Technical Service Bulletin: tsb100302

New Intercooler Connection Hose

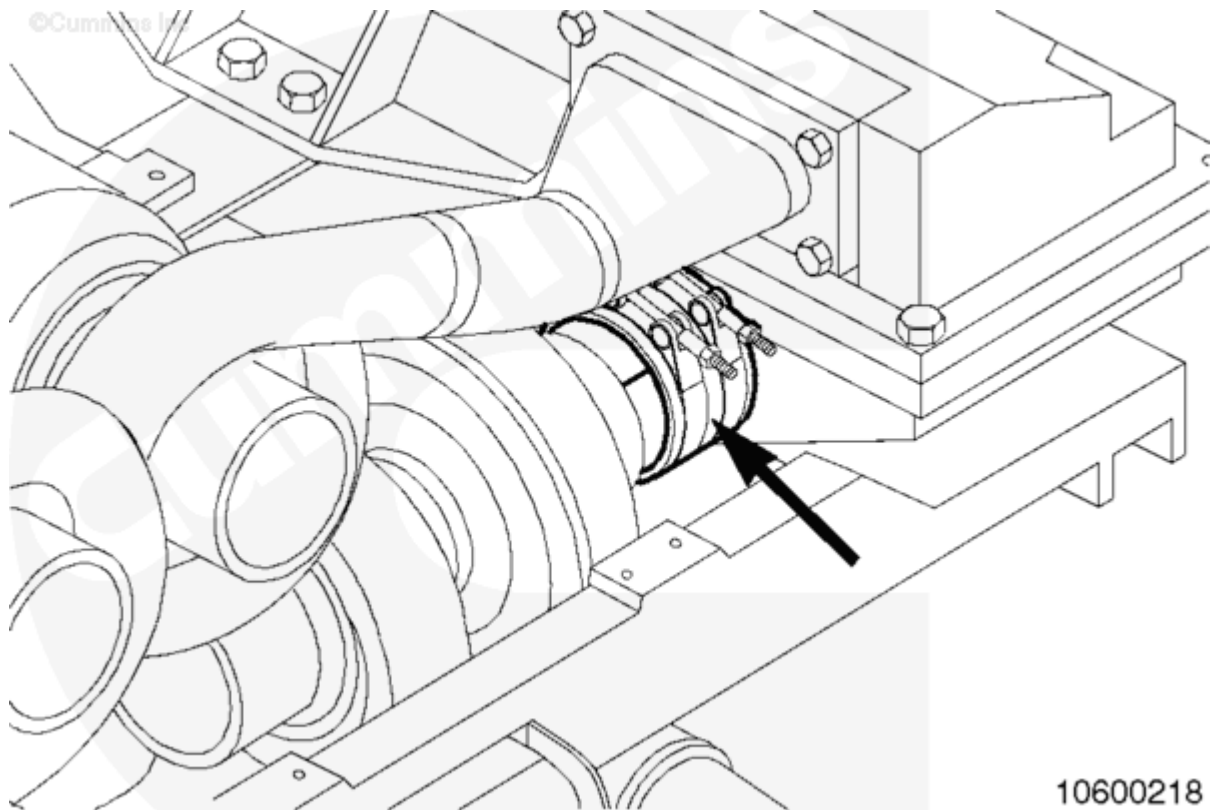
This Technical Service Bulletin details the introduction of a new intercooler connection hose on the dual stage QSK60 series engines. The new hose has been released to improve hose durability. The hose material has changed from a glass fibre material to a knitted polyester hose material.

| Criteria    | Old Hose    | New Hose          |
| Part Number | 4100590     | 3636448           |
| Material    | Glass Fibre | Knitted Polyester |
| Color       | Orange      | Blue              |

This change was implemented into production beginning with Engine Serial Number first of 33157569, built 23rd August 2004.
